## Product Change Notice

PCN#: EE-PCN21010

Fuse body color change

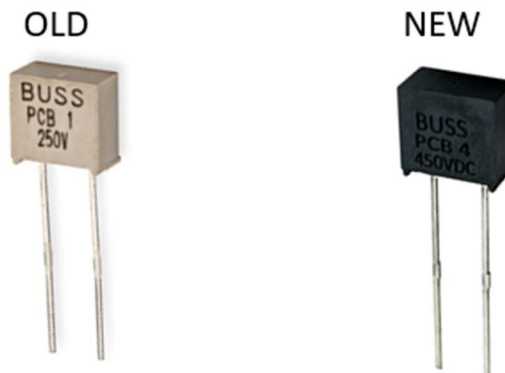
The PC Tron fuse body will change from dark tan to black. The plastic resin grade and formulation remain the same.
